CHEM-NUCLEAR SYSTEMS, LLC

Subject: Amendment Request for the CNS 10-160B Certificate No. 9204, submitted 10 May 2000
Reference: Request for Additional Information for Amendment to the Model No. CNS 10-160B Package, issued 29 September 2000

**RESPONSES TO NRC COMMENTS ON REVISION 16 OF THE
CNS 10-160B SAFETY ANALYSIS REPORT**

Figure 1
BCLDP Methodology for Determination
of Radioassay Properties for RH-TRU Waste

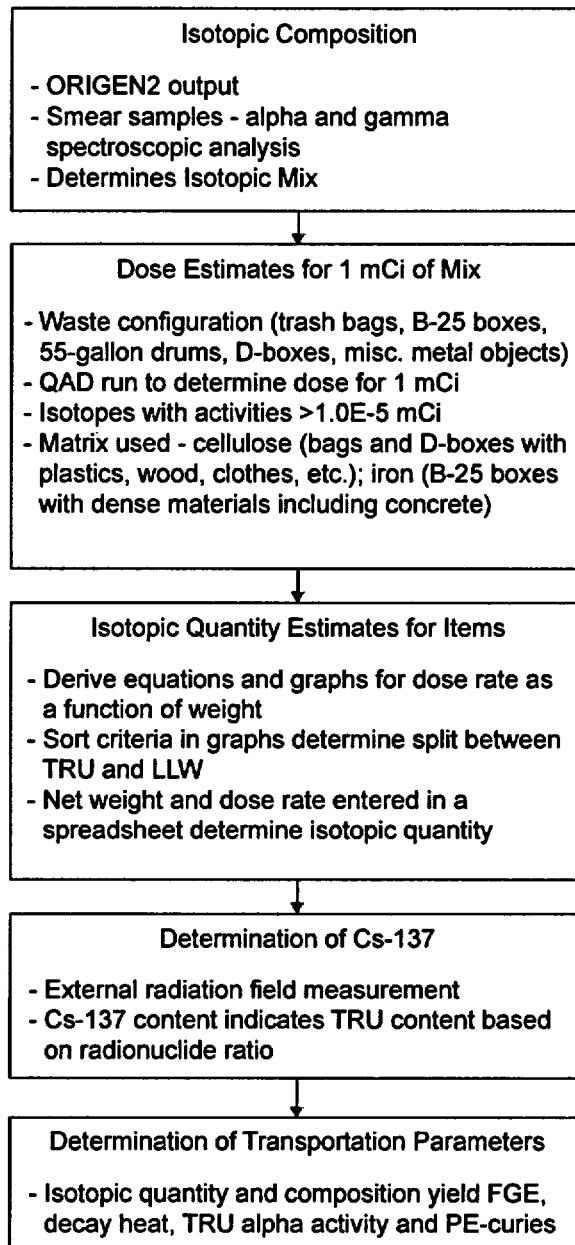
4.10 Revise Attachment B of Appendix 4.10.2.1 to describe how the ORIGEN code is used to determine radioassay properties of RH-TRU wastes and how this determination is conservative with respect to the actual isotopic distribution of the Model No. 10-160B contents. Also, state the version of the ORIGEN code that is used for this application. In addition, provide a sample ORIGEN input used for determining RH-TRU waste isotopic content.

Appropriate text has been added to Section 2.0, Attachment B of Appendix 4.10.2.1 to describe how the ORIGEN2 code is used to determine radioassay properties of RH-TRU wastes and how this determination is conservative with respect to the actual isotopic distribution of the 10-160B contents. A sample of the ORIGEN2 input that was used for determining RH-TRU waste isotopic content has also been provided along with this submittal.
